**HISTORIC PRESERVATION REVIEW BOARD
STAFF REPORT AND RECOMMENDATION**

Landmark/District: **Mount Pleasant Historic District** (x) Consent
Address: **3446 Oakwood Terrace NW**

Meeting Date: **September 28, 2017** (x) Addition
Case Number: **17-582**

The rear of 3446 Oakwood Terrace and its neighbors.

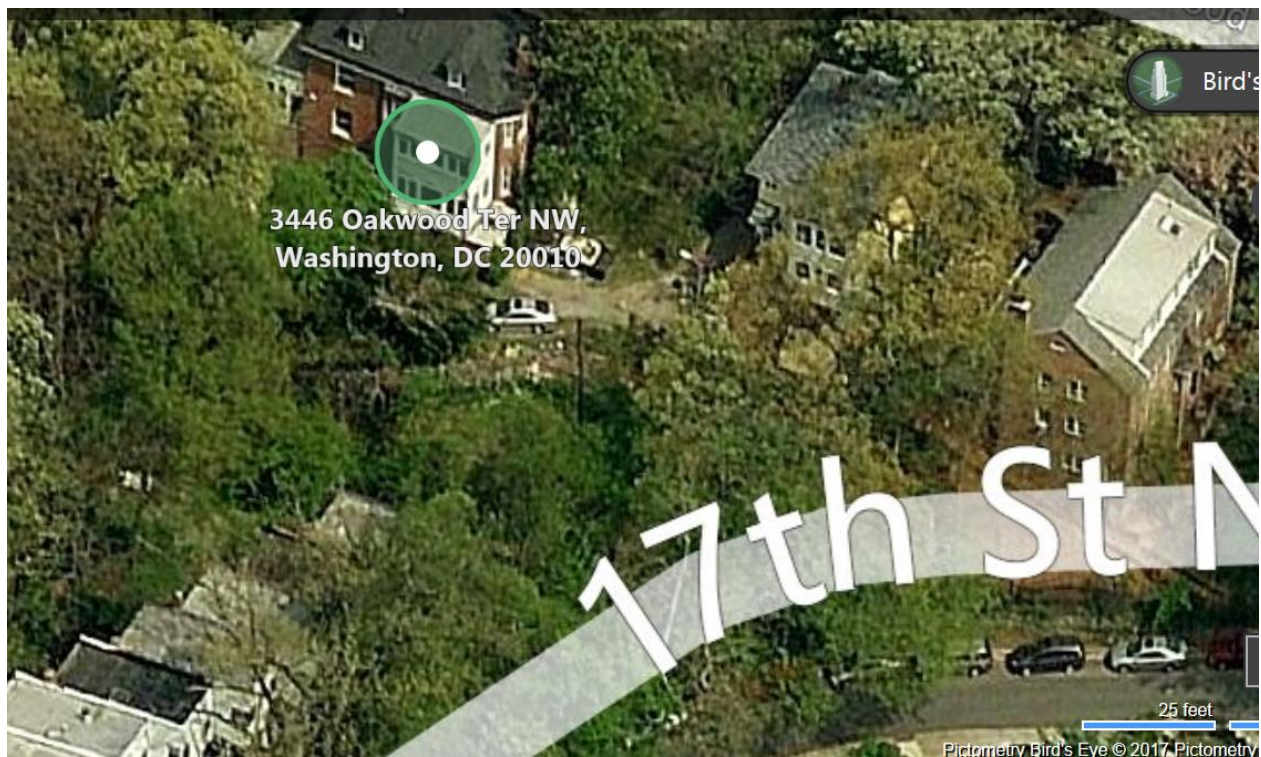
The project offers two advantages in terms of retaining the character of the historic district. First, the demolition is kept to a minimum. Second, the house stands at the northern edge of the historic district, and the addition would only be slightly visible from neighboring historic properties, including the rear yards of the row below on 17th Street, and the rear yards of the nearest homes on the west side of Oakwood. From the latter vantage point, the addition would be seen end-on, poking a few feet beyond the existing enclosed rear porches.

The fact that the addition abuts the enclosed porches is a drawback, as they should ideally stand free as they always have. And at some point, a large field of siding starts to feel somewhat barn-like. Yet, this is mitigated somewhat by the two structures being of different depths, providing a visual break. But this house will now be encapsulated on two elevations by sided structures. To relieve this slightly, but in a meaningful way, the north end of the addition should be pulled southward a bit, to expose the return of the house's northwest brick corner.

- 1. that the north end of the addition be pulled several inches southward to expose the return of the house's northwest brick corner;*
- 2. that the siding be horizontal fiber-cement lap siding not to exceed six-inch exposure;*
- 3. that the addition have corner boards; and*
- 4. that its balconies have solid steel or iron railings.*
